Report of the Head of Planning & Enforcement Services

Address 8 SUNNINGDALE AVENUE RUISLIP

Development: Demolition of existing residential care home and the erection of a two storey, with habitable roof space, detached building comprising 8 two-bedroom flats with associated parking and amenity space and installation of new vehicular crossover to front

LBH Ref Nos: 19038/APP/2010/770

GROUND FLOOR PLAN

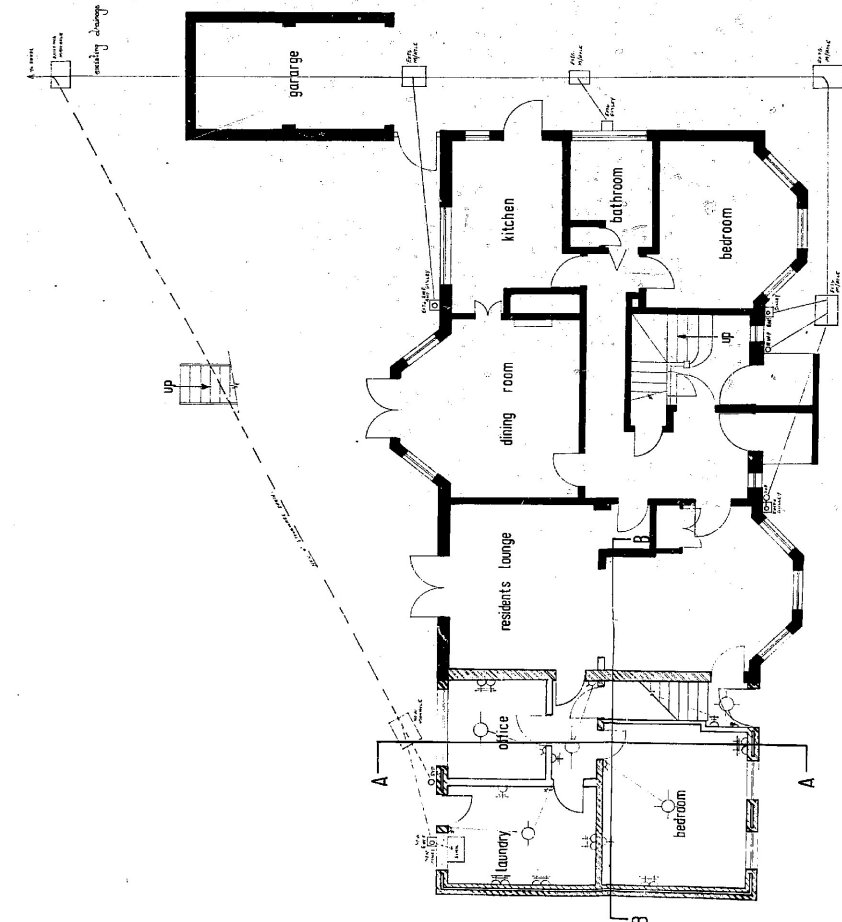
Bedroom 2 in flats 1-6 does appear to be too small to hold more than a single bed, if it is even possible to accommodate a single bed in these rooms.

The ground floor drawing states that the staircase can take a chair lift. This is not a satisfactory arrangement for other flat dwellers. These being two bedroom flats, it is assumed that they are family homes, therefore at times pushchairs and prams will need access to the stairways, and this will not be possible with a stair lift in situ.

1. The communal entrance door appears to be stepped and would be contrary to the above policy requirements if that were the case. Details of internal and external levels should be submitted to confirm that level or gently sloping access will be achieved.
2. In line with the Council's above-mentioned SPD, at least one communal lift should be provided to serve the units above ground floor level.
3. All internal doorways, including the proposed wet room doors, must provide a minimum clear opening width of 750 mm.

Recommendation: Revised plans should be requested and received prior to any grant of planning permission.

CYCLE STORE

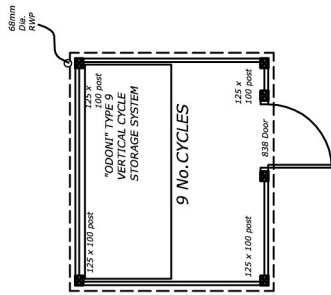
The Council's minimum cycle parking standards stipulate a requirement of 8 cycle storage spaces for this development. The proposed cycle storage would not be suitable for 8 cycle spaces.

However, the Highway Engineer does raise concern with the proposed parking, access and cycle parking arrangements. The width of the proposed crossover, together with that of the adjoining crossover at No.6 would be undesirably long and create the potential for vehicular and pedestrian conflict. The width of the driveway leading to the rear car parking area at 3m is also not adequate to allow two cars to pass and therefore, the likely result would be for cars to wait and/or having to reverse onto the highway. Two of the bays also have unsatisfactory turning circles. The lack of a pedestrian path on the driveway is also a concern, as are the adequacy of the visibility splays at the entrance, given that no trip information has been submitted to clarify whether its use would intensify with this proposal. The cycle storage provision is also inadequate for 8 cycles.

BIN STORE

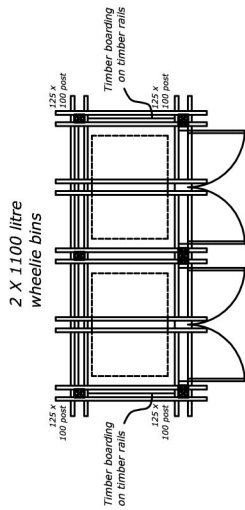
The bin and recycling store is situated in the front garden. Having bins in front gardens is not a feature of this area, therefore this will be detrimental to the street scene.

b) The dimensions of the bin compound should ensure there is at least 150mm clearance in between the bins and the walls of the chamber, based on the size of bin above. The height of the chambers should be at least 2 metres, to allow the lids of the bulk bins to be fully opened.

The proposal makes adequate provision for refuse/recycling storage. Revised details would have been sought by condition to ensure that the storage area did not obstruct the view of the building entrance if the application had not been recommended for refusal.
